Ramsey West Site (Downtown Saint Paul):

Ramsey County West Tiering

SAINT PAUL
PLANNING & ECONOMIC
DEVELOPMENT

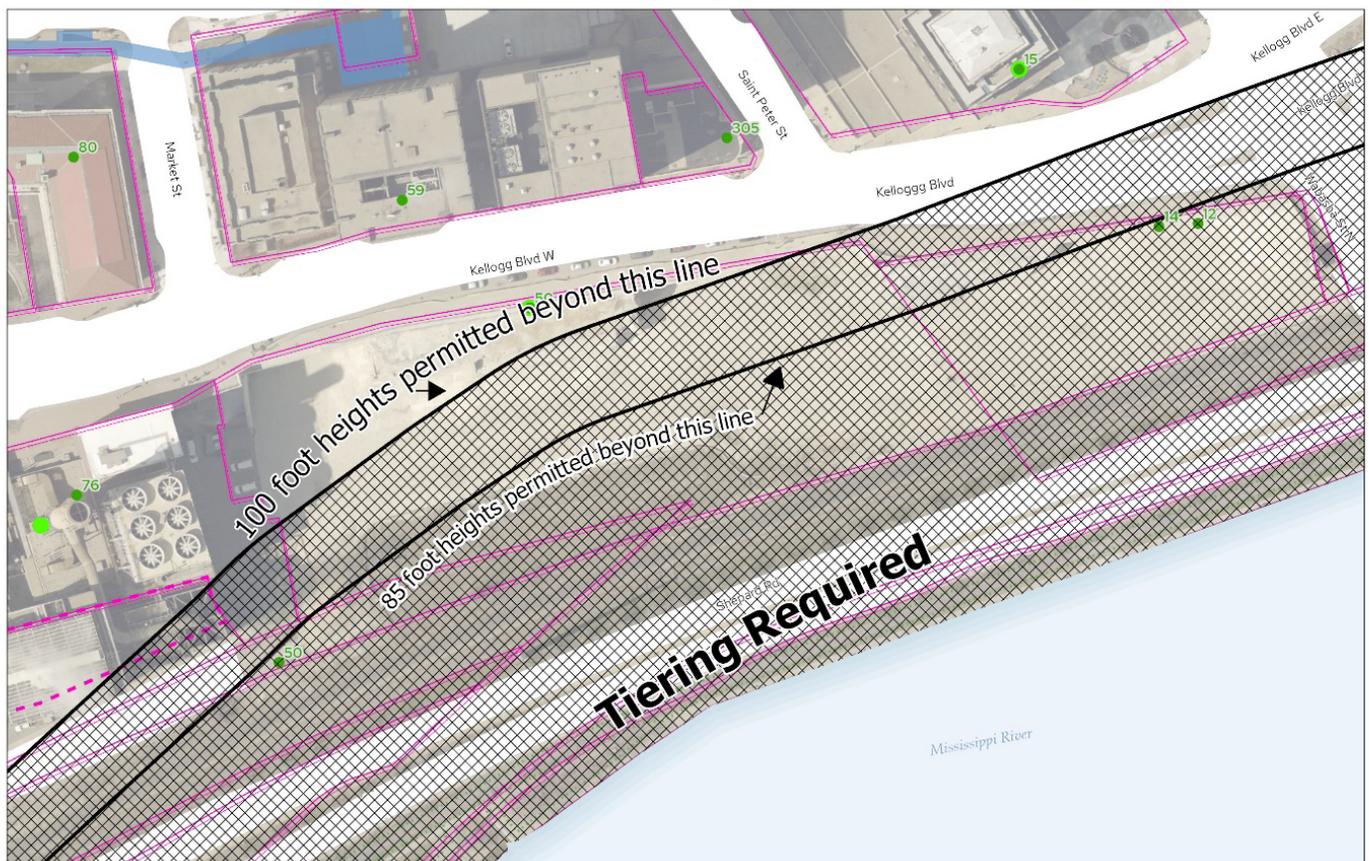
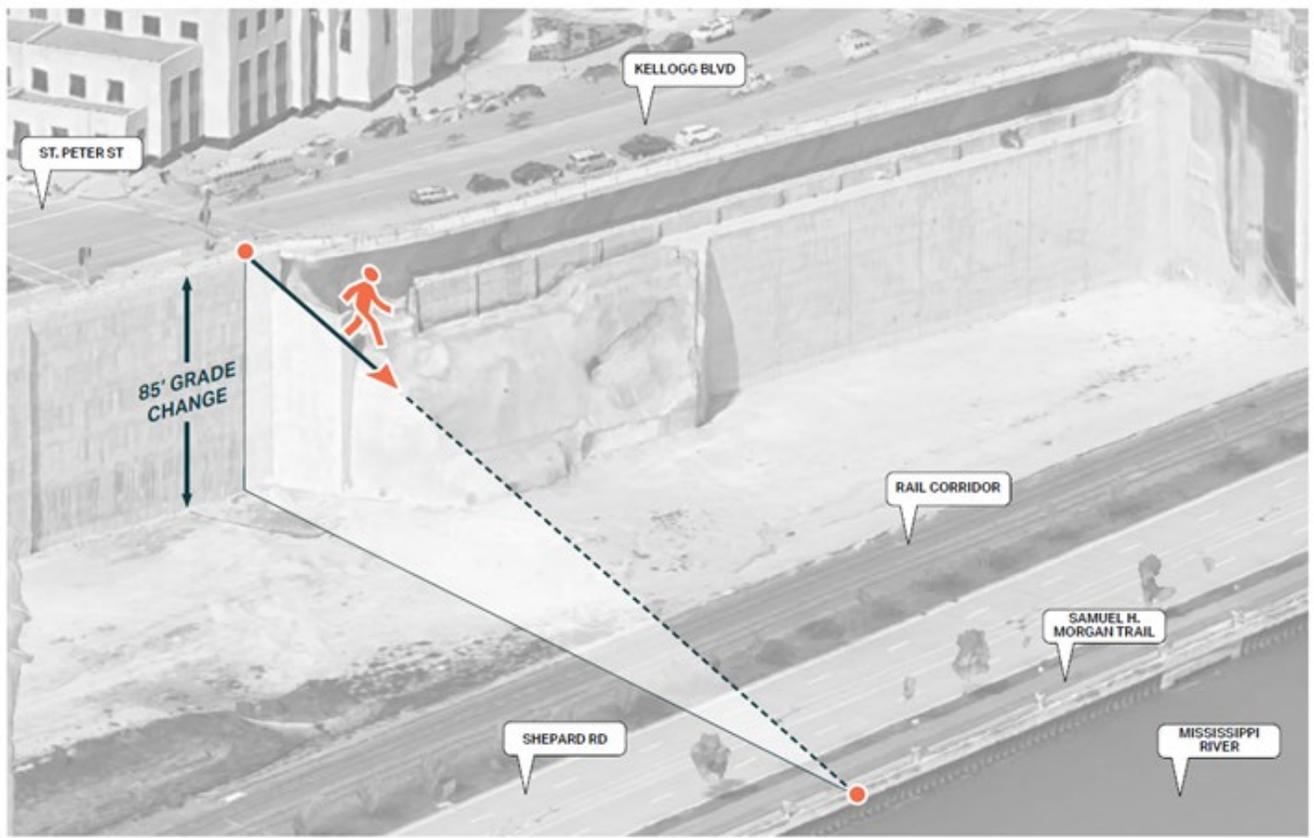
Under Mr. Torstenson’s proposal, the UC District would be subject to a 35-foot base height at the shoreline, with a 1-foot height increase for every 5 feet of distance a structure is from the river. This approach would be highly restrictive in a downtown context, where the bluff is approximately 85 feet high. If adopted, this approach would only allow development that is constructed at the toe (the bottom) of the bluff to project approximately one or two stories over the bluff line (top of the bluff). This height limitation would effectively prevent the development concepts proposed by Ramsey County for this site from advancing without a large MRCCA height variance. Additionally, the curvilinear nature of the river near this site further complicates implementation, making setback-based height calculations difficult to administer and creating significant design challenges for future developers.

Staff does not recommend amendments to lower base heights as proposed by public hearing testimony, because the suggested height amendments from public testimony are:

- overly restrictive in the UC district and would not permit reasonable downtown development projects as envisioned without height variances (Mr. Torstenson’s version of amendments); and the setback formula in the RTC and UM districts would not result in less subjective tiering requirements for most new developments.
